Project Title: 214539 Planning Application Land adjacent C1059, Hatfield, Leominster HR6 0SG Proposed residential development of five dwelling houses with associated vehicle access from C1059	Job Number: CWC105
	Date: 25/04/2025
Subject: Discharge of Conditions 6 and 10 Revision 2

This report version seeks to address the data and detail requests made by the council Land Drainage team in comments made on 14 March 2025. These are summarised as:-

Figure 1: Extract of drawing Drainage Mound Details number CWC105-DR-03 Revision P03.

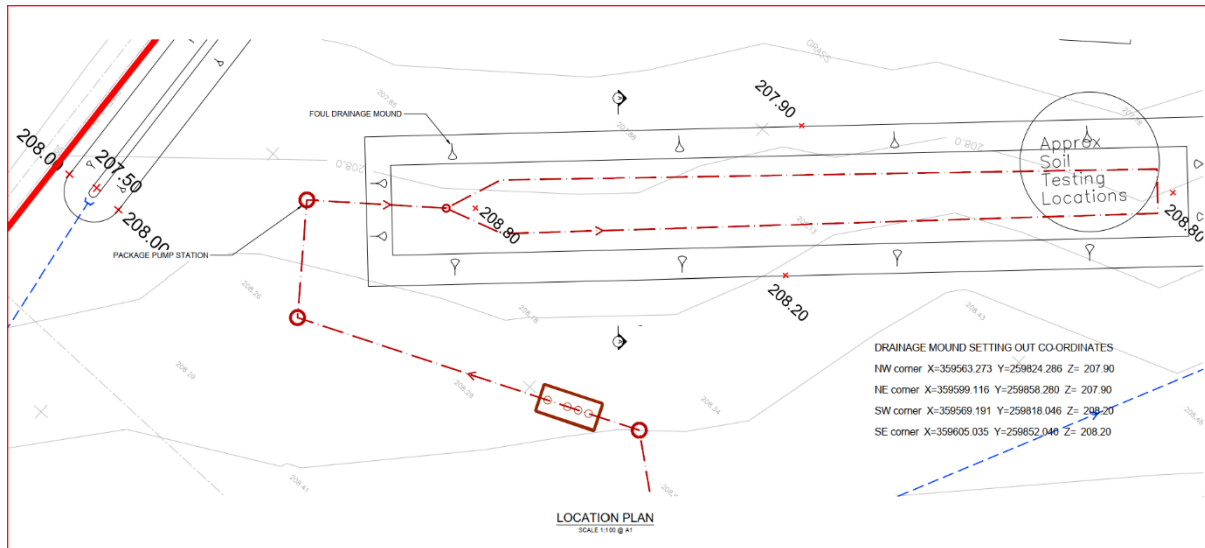
- Condition 10 can be discharged. It has however been retained in this version of the report for ease of reference.
- Condition 6 additional details are required relating to:
 1. Drainage mound setting out co-ordinates should be provided. See Clause 1.2.2 and drawing Drainage Mound Details number CWC105-DR-03 Revision P03.
 2. Further details are required about the pump station, alarms and emergency storage. See Clause 1.2.3 to Clause 1.2.5
 3. Maintenance details are required for the foul pump station. See Clause 1.4.
 4. A dosing chamber or flow buffering system should be included between the pump station and the internal mound distribution pipework. See further details in Clause 1.2.5 and the details of chamber F1007 within the drawings in Appendix A.

In the previous version of this report Drawing CWC105-DR-01 Rev P02 showed the mound as a rectangular shape as the contours are relatively straight, whereas Drawing CWC105-DR-03 Rev P02 had not been updated to also show the more uniform rectangular shape.

This report ensures that a rectangular mound is shown in every instance, plus it provides the setting out coordinates of the mound corners. The coordinates have also been added to the drawings. The uniform shape is achieved by a minimal amount of earthworks to create finished ground levels of 208.20m along the upslope side and 207.90m on the downslopes side.

The mound cross section details and the setting out co-ordinates of the toe of the mound are given below. The co-ordinates have also been added to the drawings, see Appendix A and Figure 1.

DRAINAGE MOUND SETTING OUT CO-ORDINATES

NW corner X=359563.273 Y=259824.286 Z= 207.90

NE corner X=359599.116 Y=259858.280 Z= 207.90

SW corner X=359569.191 Y=259818.046 Z= 208.20

SE corner X=359605.035 Y=259852.040 Z= 208.20
